Technical Service Bulletin

| Subject: LIGHT RESISTANCE AND/OR UNUSUAL NOISE WHEN TURNING STEERING WHEEL LEFT OR RIGHT | Bulletin No.: 06-001/21 |
| | Last Issued : 09/16/2021 |

| Bolt at Steering Wheel | Bolt Set at Start Stop Unit |

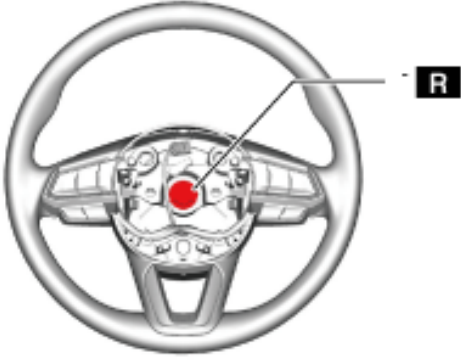
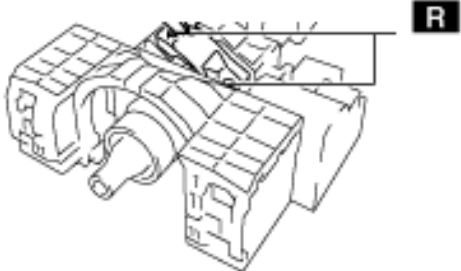
[R] Parts (*1) (*2) Location:

| Parts Number | Description | Qty. | Notes |
|--------------|-----------------|------|-------------------------------------|
| 9YA0-11-003A | Bolt | 1 | [R] (*1) |
| KA01-66-154 | Bolt, Set | 2 | [R] (*2) |
